Research Report 1524

# MANPRINT Evaluation: AN/TRC-170 Digital Troposcatter Radio System

Gregory S. Krohn and Samuel E. Bowser  
Essex Corporation

June 1989

Figure 8. The M-720 mobilizer carrying the S-665 shelter. (The actual configuration of the mobilizer differed slightly from the graphic representation.)

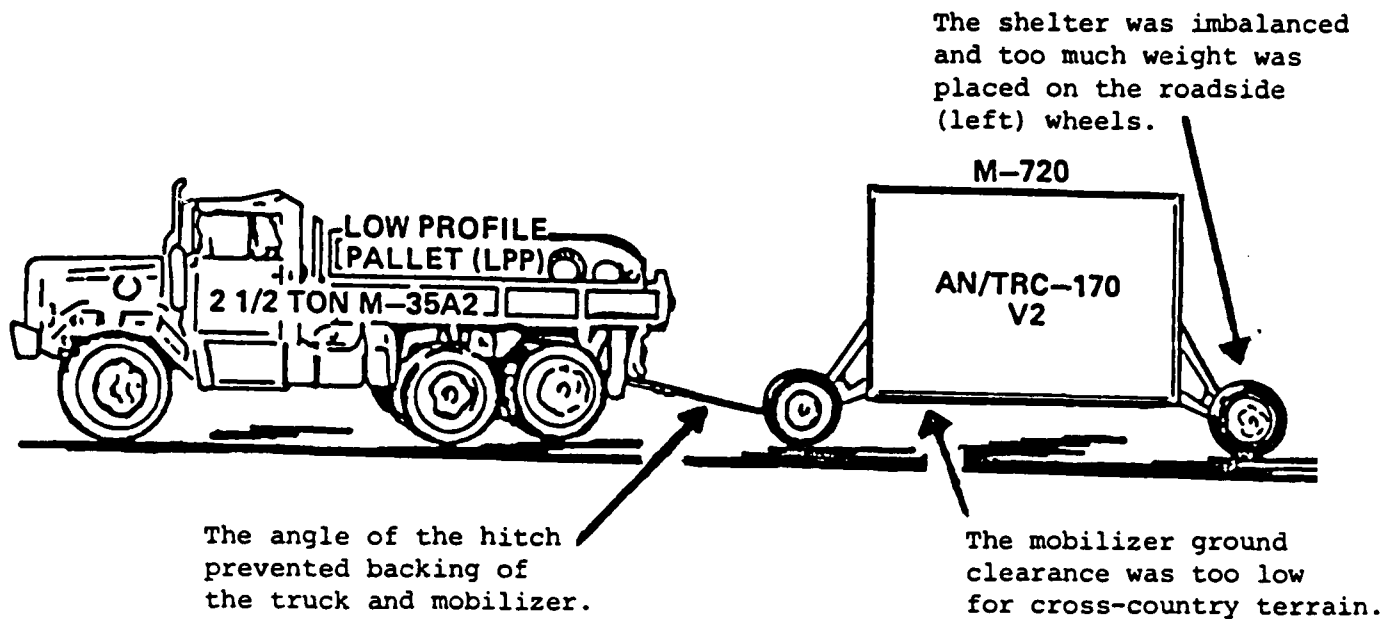
Description of the Problem: Figure 8 shows the M-720 Mobilizer which carries the V2 shelter. The M-720 Mobilizer carrying the V2 electronic and some of the antenna equipment had several limitations on its mobility including:

- a. The loaded mobilizer weighed 8,620 lbs when loaded with tactical cargo. The load was 1,150 lbs over the gross weight of the authorized load of 7,470 lbs. The distribution of the weight was unbalanced when the mobilizer was loaded according to the load plan. The left side wheels carried weights of 2,290 lbs and 2,430 lbs for the front and rear wheels. The loads over the left side wheels were 490 lbs and 630 lbs over the 1,800-lb load limit for each wheel. The right side wheels were weighted below the 1,800-lb. load limit.

- b. The ground clearance of the mobilizer was 12 inches below the center of the trailer. The mobilizer struck terrain during cross-country travel and could not cross rough terrain that could have been crossed by the towing vehicle.

- c. The mobilizer cannot be driven in reverse when towed due to the angle of the trailer tongue when hitched. The trailer tongue was raised approximately 2.5 ft at a 35-deg angle when it was attached to the hitch of the 2.5-ton truck. Backing the mobilizer would result in equipment damage to the hitch or tongue as forces would cause the tongue to fold over.

Potential Solutions: The internal shelter configuration had all the electronic components positioned on the roadside of the mobilizer. Perhaps the electronic components could be repositioned on both sides of the mobilizer in order to balance the load. However, the only way to avoid exceeding the weight capacity of the mobilizer may be to use a larger-capacity mobilizer.

Figure 9. The main power panel in the V3 shelter.

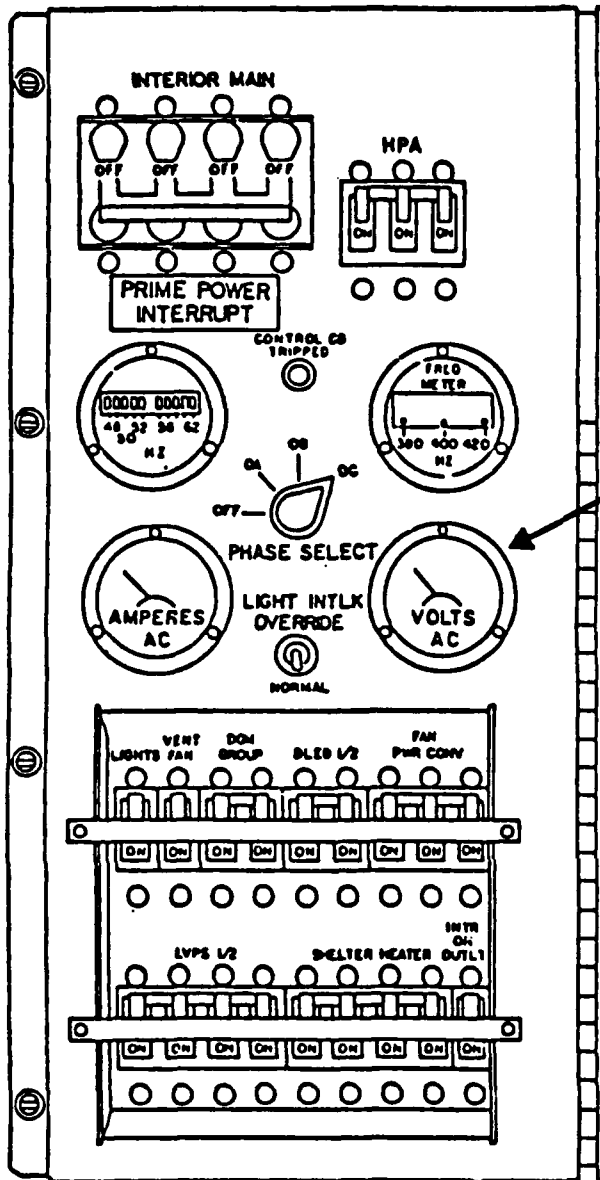
Description of the Problem: There are two 10 kw generators mounted on a single trailer used to support the operation of the V3 system. The generators have two operational problems including:

- a. The generators cannot be switched from one to the other without shutting down the V3 system. The generators need to be switched when fuel is emptied or repairs are required. Once the V3 is shut down, a period of 10 to 15 minutes is required for system warm-up before radio transmissions can be resumed.
- b. Figure 9 shows the V3 main power panel. The generators do not have a built-in capability to adjust for power load variations. When power load variations occur, the operator must see the variation on the power panel voltage meter in the V3 shelter or on the generator and then adjust the generator. Power load variations occur when components in the V3 shelter are turned on or off.

Potential Solutions: Provide the generators with switching capability that provides continuous power without power fluctuations. The generators should be able to automatically adjust for load variations.

Figure 10. The low-profile pallet that was mounted on a 2.5-ton truck and covered for transport.

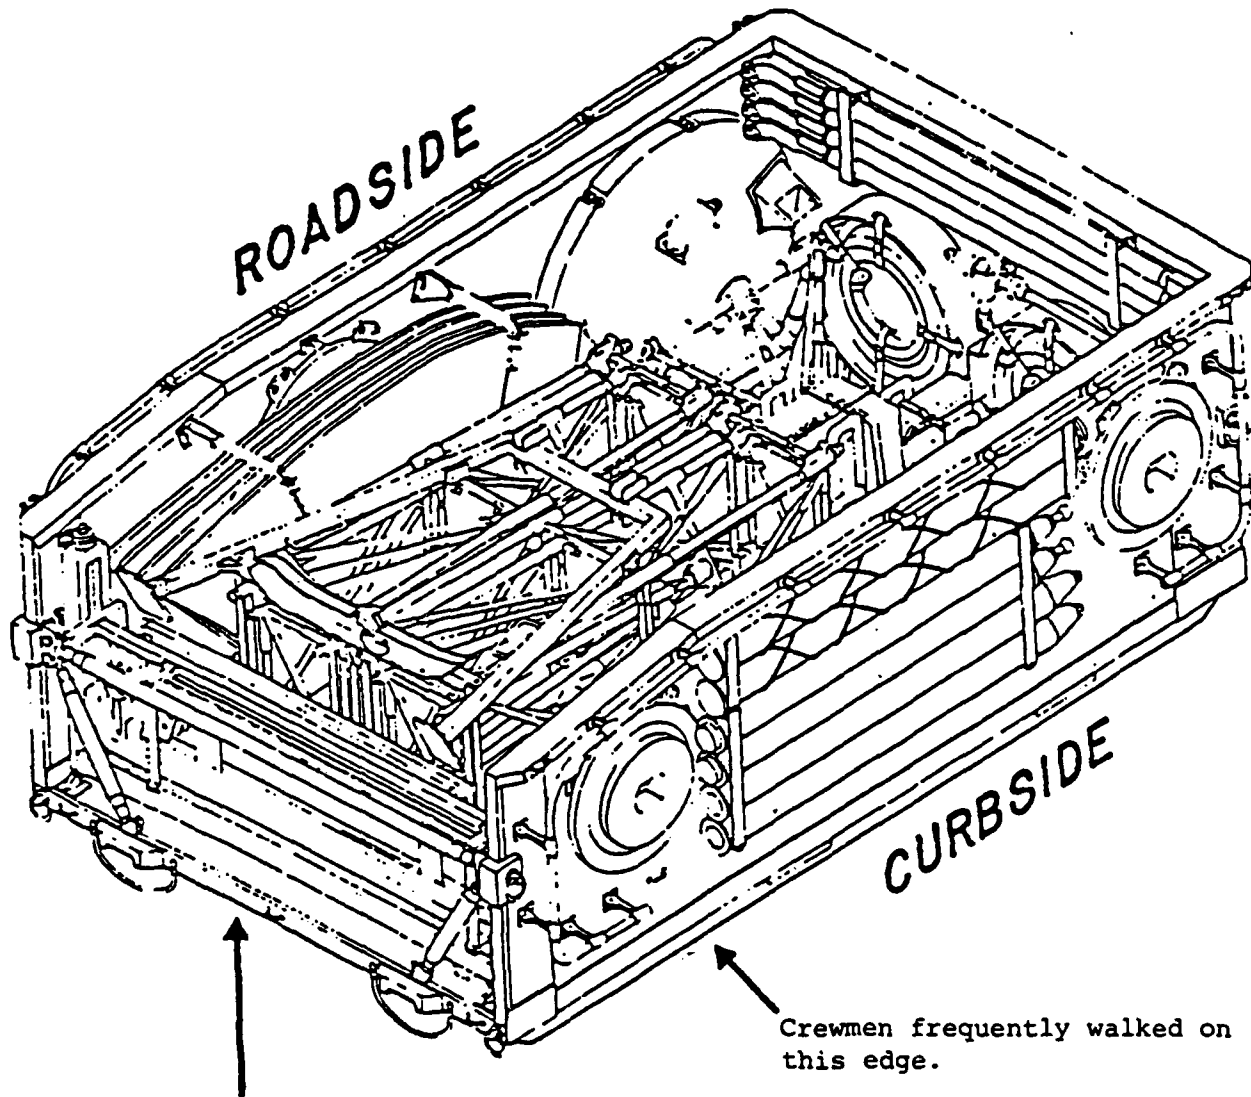
Description of the Problem: Figure 10 shows the low-profile pallet and its contents. The loading and unloading of the low-profile pallet for the V2 system (9.5 ft) antenna is unsafe to perform by three crewmen (AN/TRC-170 V2 crew size). The weights that must be lifted and carried exceed MIL-STD-1472C maximums for three soldiers. The unit (Heavy Tropo Company) does not have other personnel available (TO&E) to support the crews in the field to assist in lifting material. The system can not be set up with a two-man crew making the system un-emplacable if any crew member is injured or otherwise unavailable. The units may set up in isolated locations and other personnel may not be readily available.

Potential Solutions: The crew size could be increased by the addition of a maintainer (29M or 29S) to add to the number of persons available for loading or unloading. The procedures for the truss assembly might be modified to reduce the weight lifted by crewmen when disassembling the truss on the pallet.

Figure 11. The waveguide latches (a) that were difficult to close and the O-ring (b) that fell out.

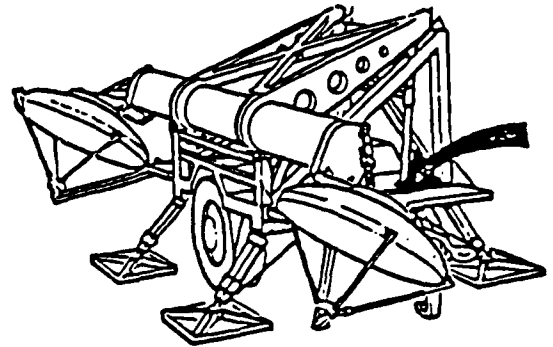
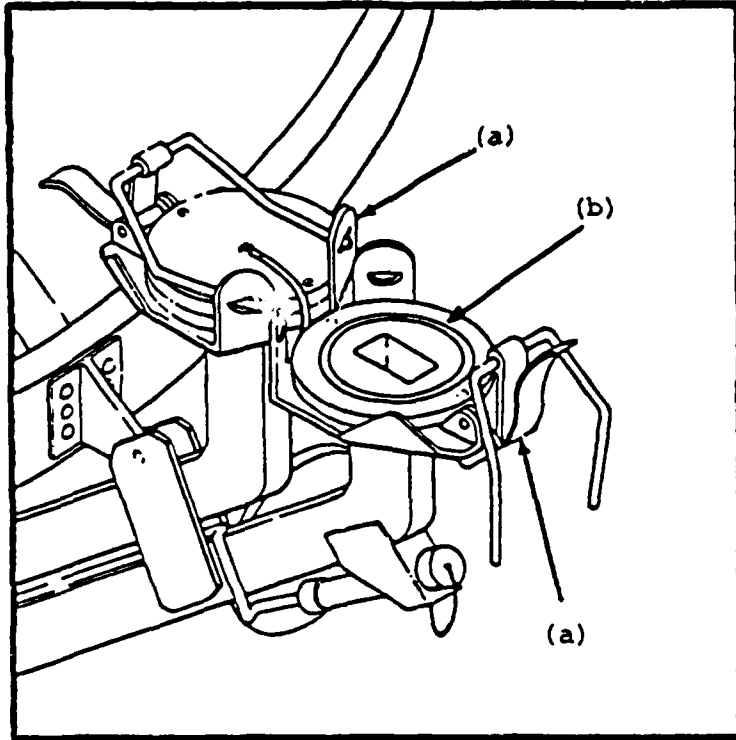
- a. The male plug alignment and signal pins bend, loosen, and fall out.
- b. The male plug O-ring forming the moisture seal falls out making alignment difficult and risking loss of the O-ring. Figure 11 shows the location of the O-ring and latch device.
- c. The latch securing the male plug to the female socket was difficult to manipulate and had to be forcibly closed. The latch could not be closed by crewmen wearing MOPP NBC gloves.
- d. The protective transport containers for the waveguides used on the V2 system were attached to the pallet. The waveguides had to be carried by crewmen from the pallet to the antenna. The exposed waveguides were often stepped on or collided with objects. Figure 12 shows the protective container, while Figure 13 shows the position of the waveguides when laid out on the ground.

Potential Solutions: The waveguides should be durable enough for the field environment in which they will be used. Operator training should address the sources and prevention of waveguide damage, especially if the design of the waveguides remains unchanged. Two soldiers, rather than one, should be used to support the waveguide when attaching or detaching it to the antenna in order to keep it evenly supported.

Figure 14. The lightning protection assembly (LPA) that was erected across the top of the antenna structures.

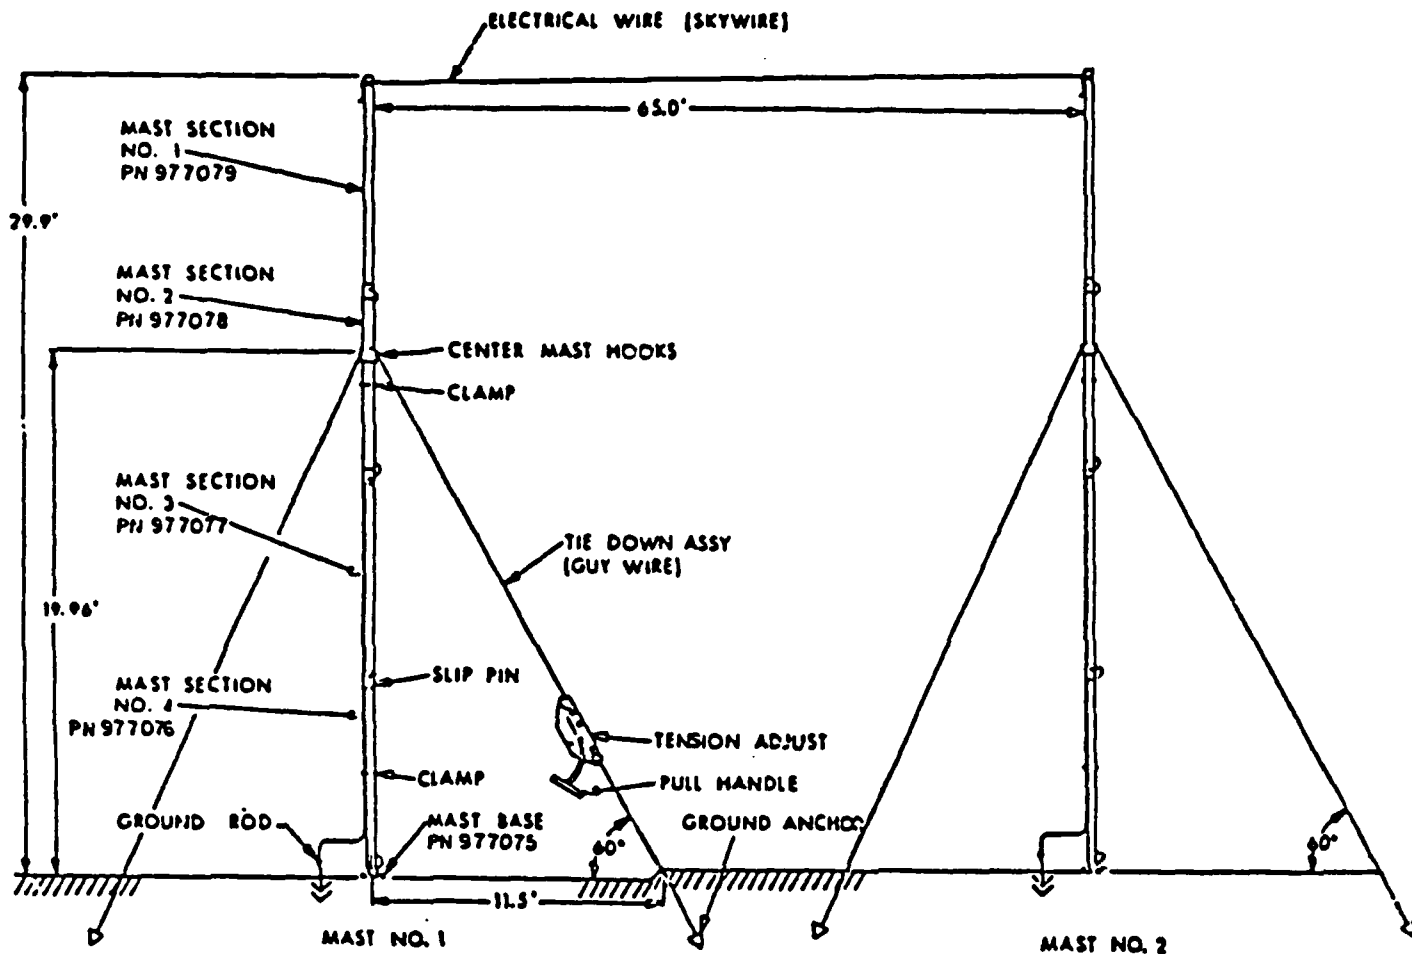
Description of the Problem: Figure 14 shows the LPA configuration that is erected across the top of the antennas. The LPA erection procedures call for four crewmen (crew size is three soldiers). The procedures require one crewman to hold the base plate, one crewman to walk the mast up, and two crewmen to hold the guywires controlling the mast as it rises. The current equipment assembly procedures and the few personnel performing the task may lead to a situation resulting in the collapse of the mast.

Potential Solutions: If the current LPA masts continue to be used, using a hinged base plate would make erection easier and safer, but for safety would require four man crews for erection. Alternately, consideration should be given to use of telescopic antenna mast sections which are already in the supply system. The training program should demonstrate correct erection/dis-assembly procedures to all 26QD6 personnel during specialty training.

Figure 15. A cut-away view of the Pionjar drive motor and of the duckbill anchor.

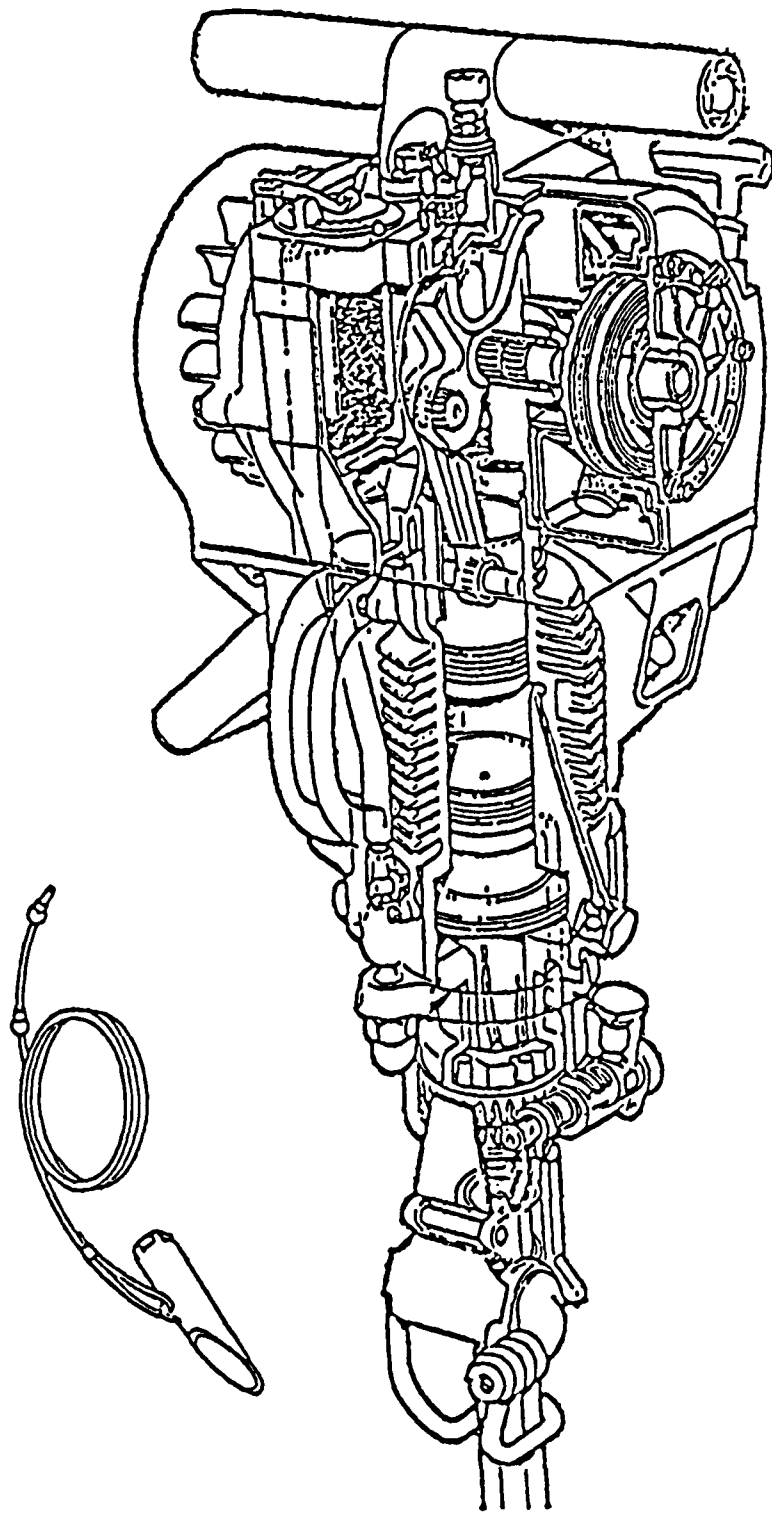
Description of the Problem: Figure 15 shows a cut-away view of the Pionjar drive motor. Problems found on the non-militarized Pionjar included:

Potential Solutions: A separate test of the Pionjar is needed. The device should also be required to meet military packaging and labeling standards. The logistics issue need review.

Figure 16. An example of the type of pin that was difficult to insert and remove.

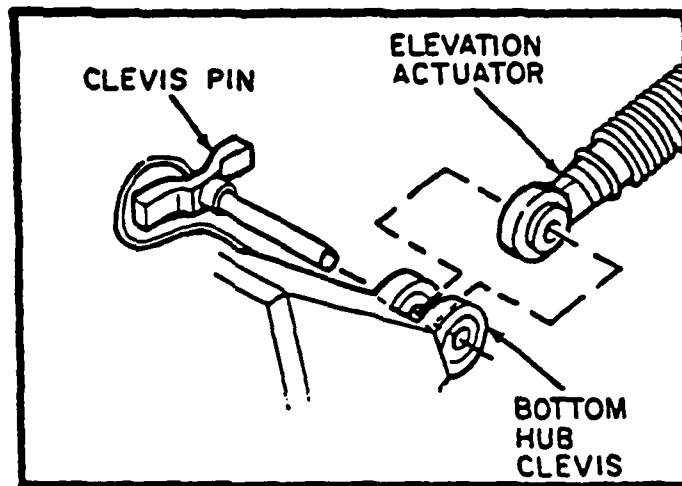
Description of the Problem: Figure 16 shows the type of clevis pins used to secure and assemble equipment. The clevis attachment pins used on the AN/TRC-170 antennas are difficult to handle. The pins are used to hold the antennas together and to secure antenna parts to the low-profile pallet. The pins fit tightly and are difficult to install and remove. The pins have been damaged by attempts to install or remove them using improper tools such as hammers, rocks, and other objects.

Potential Solutions: The pins should be treated with an approved lubricant to control corrosion and facilitate insertion. The holes receiving the pins should be flanged to help insertion/removal. Crewmen suggested that a rubber mallet be issued and used to insert or remove pins.

Figure 17. The 9.5-ft antenna (a), rear truss clamp (b), and bearing ball (c).

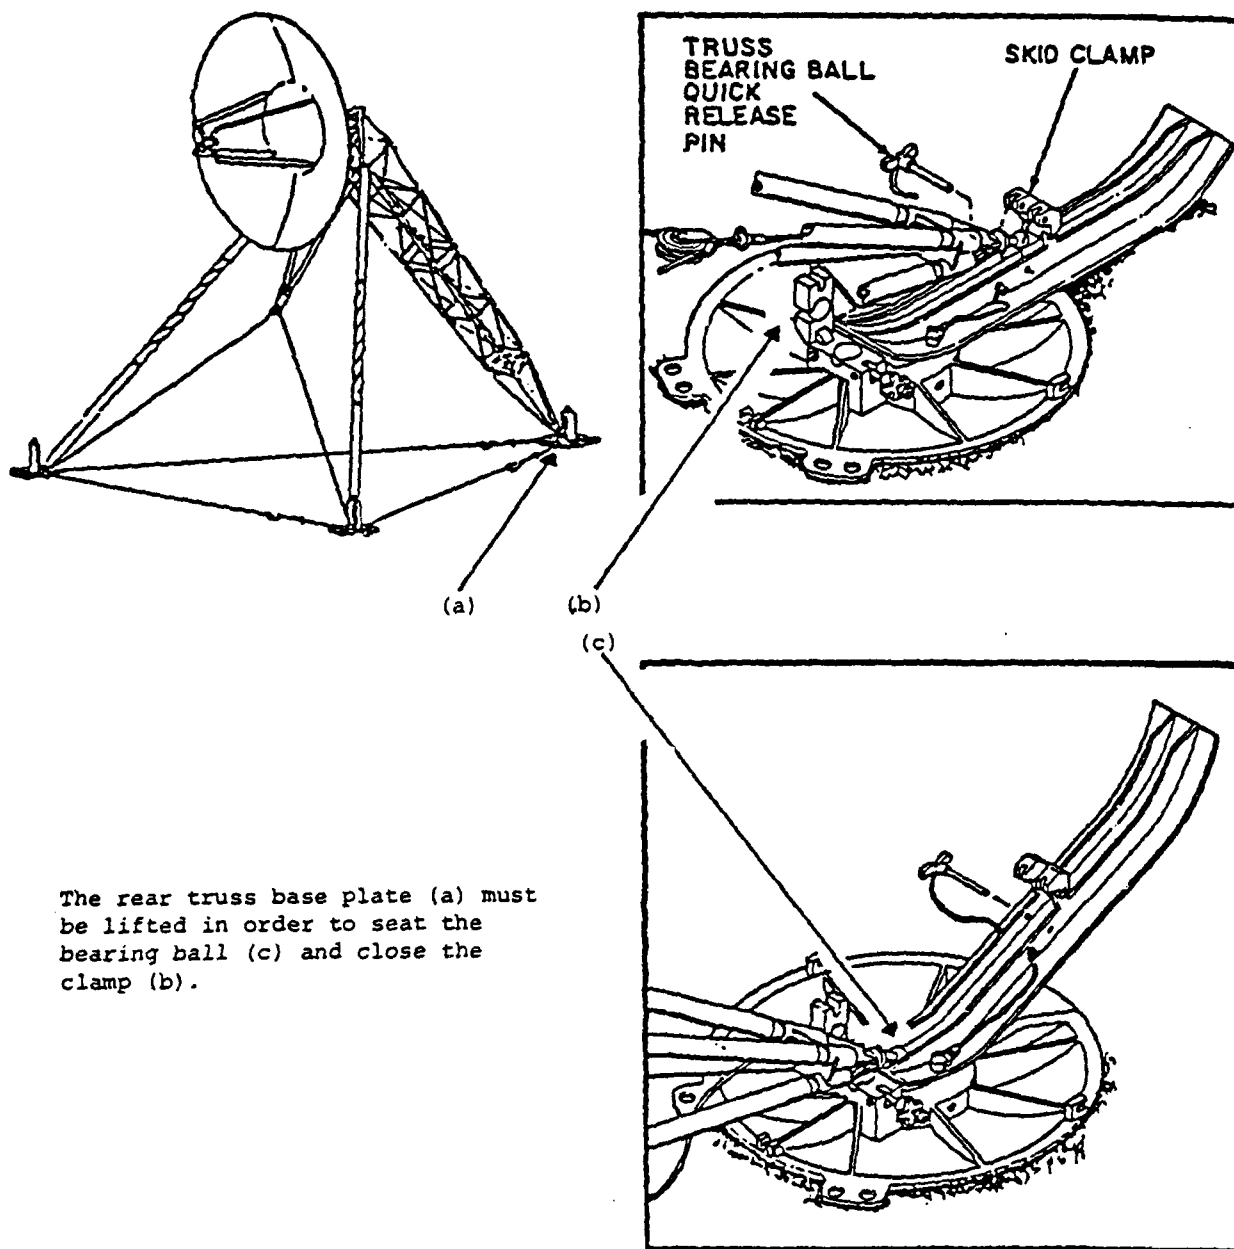
Description of the Problem: Figure 17 shows the rear truss clamp and bearing ball configuration. The rear truss clamp which locks down the bearing ball on the end of the truss assembly binds. The clamp cannot be closed without lifting the loaded base plate, a job that is heavy and dangerous. The problem occurs when the antenna is set to the 15-ft height versus the 10-ft height.

Potential Solutions: The rear clamp assembly needs to be modified. The new antennas in production should be modified prior to fielding.
